PZ&B Staff Combination Memorandum: Architectural Commission and Town Council

SUBJECT: ARC-23-137 (ZON-23-104) 310 CLARKE AVE

MEETING: DECEMBER 15, 2023 ARCOM
JANUARY 10, 2023 TC

The applicant has submitted plans, entitled “MODIFICATIONS TO PREVIOUSLY APPROVED NEW RESIDENCE @ 310 CLARKE AVENUE” as prepared by **MP DESIGN & ARCHITECTURE**, dated December 04, 2023.

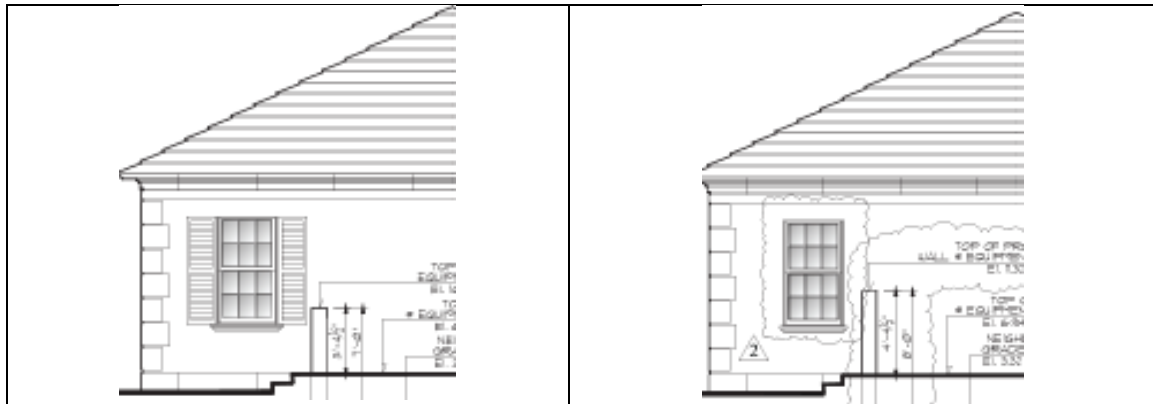
Architectural changes to the structure are relatively minor and include changes in railing design at front and rear balconies, change in loggia columns, elimination of shutters on the east and west elevations at the garage/kitchen wing, and slight modification to the outdoor kitchen area including addition of an installed tile mosaic on the south façade. Changes of this level can often be reviewed and approved at the staff level with consent of the Chairman, however, due to the other outstanding issues requiring variances, the entirety of the application was required to return to the commission, rather than bifurcating approvals.

Western Equipment Yard Plan Diagram

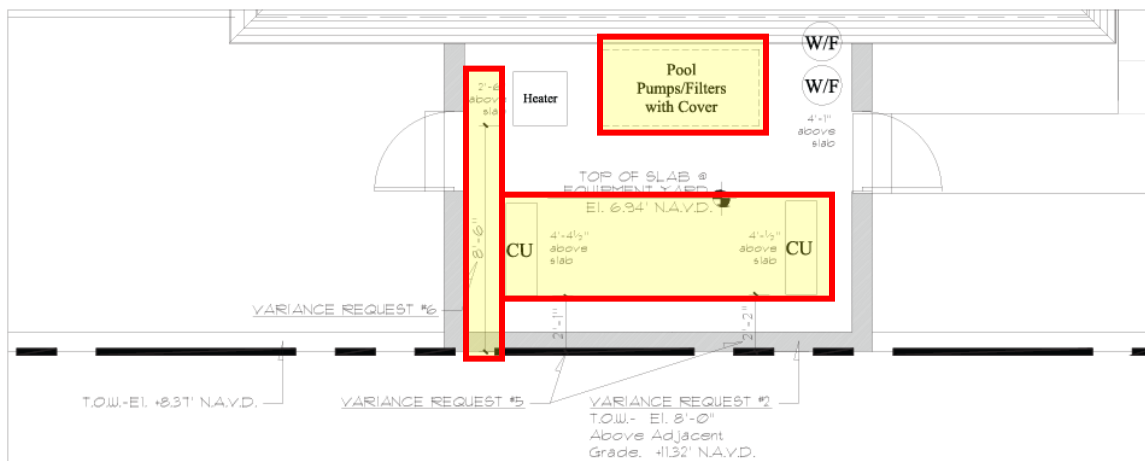
Variances for A/C equipment closer than 5' to property line, and 3 pieces of A/C equipment in setback.

Eastern Equipment Yard Plan Diagram

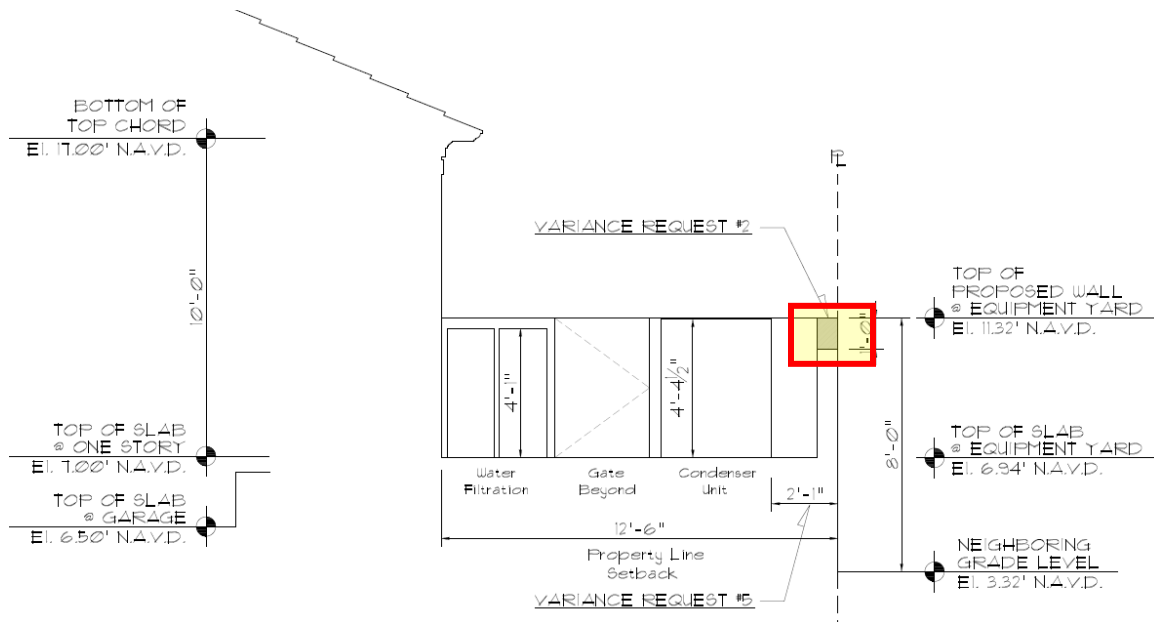
Variance for pool heater less than 10' to property line. Variance for A/C equipment less than 5' to property line. Variance for pool pumps/filters unhooused.

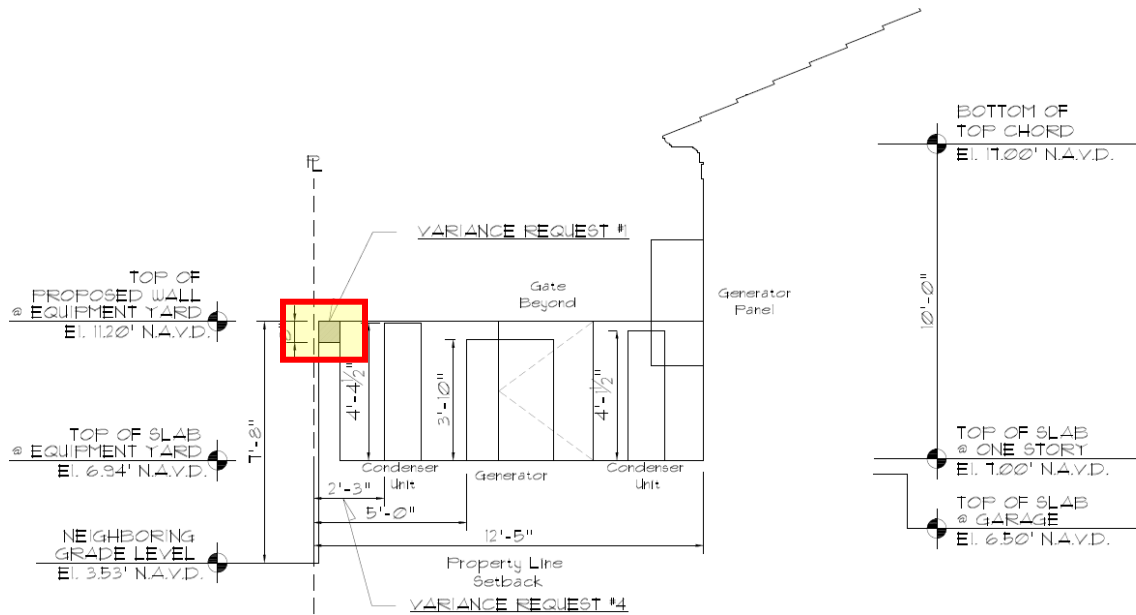
Variance for equipment wall to exceed max. 7' height above lowest grade.

Variance for equipment wall to exceed max. 7' height above lowest grade.

Option 1: Proposed configuration and variances in east side-yard.

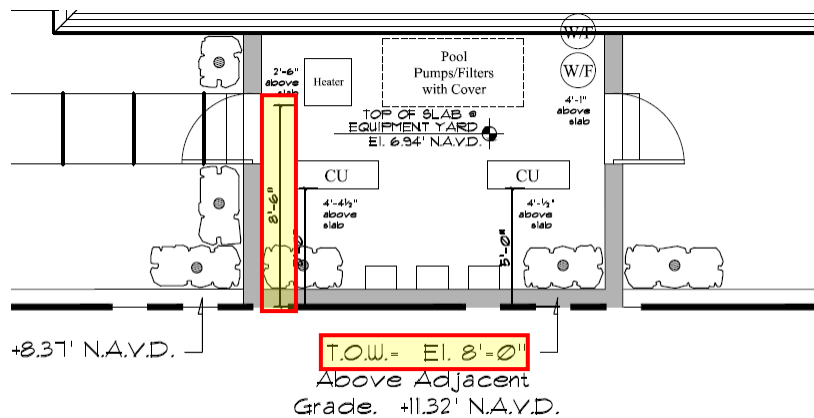
Option 1 includes rotating the two pieces of A/C equipment in the east side yard to provide the minimum 5' setback required (*eliminating variance number 5*). The pool equipment in the east side yard is now covered as required by code (*eliminating variance number 7*). The pool heater is proposed to remain as previously presented with an 8.5' side yard setback in lieu of the 10' required, *variance number 6*). The previously presented 8' high equipment yard screening wall is also proposed to remain in lieu of the 7' max height permitted, which will require a variance (*variance 2*). New hedge material is proposed in and around the east side yard to aid in screening the equipment area.

Option 2: Proposed configuration and variances in west side-yard.

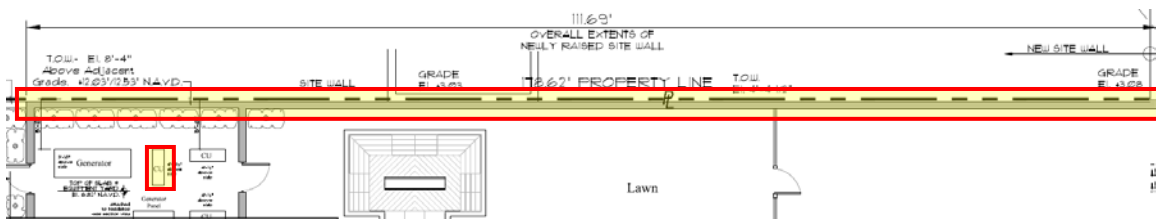
In the west side yard, two pieces of A/C equipment are shifted to meet the 5' setback required (*eliminating variance 4*). Three pieces of A/C equipment are still proposed within the 12.5' setback, where a maximum of 2 pieces are permitted (*variance number 3*). Option 1 also proposes to further raise and expand the equipment screening wall from previously proposed, now at 8'4" in lieu of the 7'8" previously proposed and 7' maximum permitted (*variance 1*), along a majority of the west site wall. Hedge material is also proposed in and around the equipment yard for screening.

Option 2: Proposed configuration and variances in east side-yard.

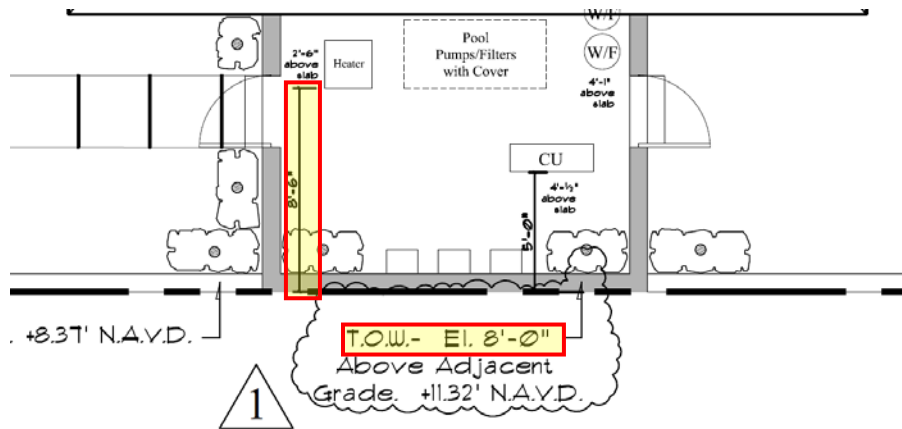
Option 2 includes rotating one piece of A/C equipment in the east equipment yard to meet the minimum 5' setback required, and removing one piece of A/C equipment completely and relocating at the garage in the rear yard area (*eliminating variance number 5*). The pool equipment in the east side yard is now covered as required by code (*eliminating variance number 7*). The pool heater is

proposed to remain as previously presented with an 8.5' side yard setback in lieu of the 10' required, variance number 6). The previously presented 8' high equipment yard screening wall is also proposed to remain in lieu of the 7' max height permitted, which will require a variance (variance 2). New hedge material is proposed in and around the east side yard to aid in screening the equipment area.

Option 2: Proposed Configuration and variances in west side-yard.

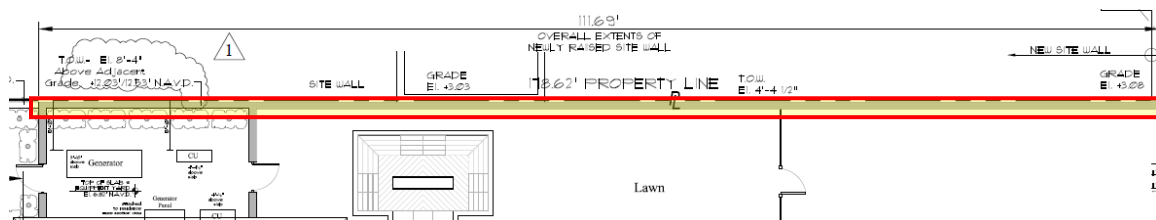
In the west equipment yard, one piece of A/C equipment in the east equipment yard to meet the minimum 5' setback required (*eliminating variance number 4*), and removing one piece of A/C equipment completely and relocating at the garage in the rear yard area (*eliminating variance number 3*). Option 1 also proposes to further raise and expand the equipment screening wall from previously proposed, now at 8'4" in lieu of the 7'8" previously proposed and 7' maximum permitted (variance 1), along a majority of the west site wall. Hedge material is also proposed in and around the equipment yard for screening.
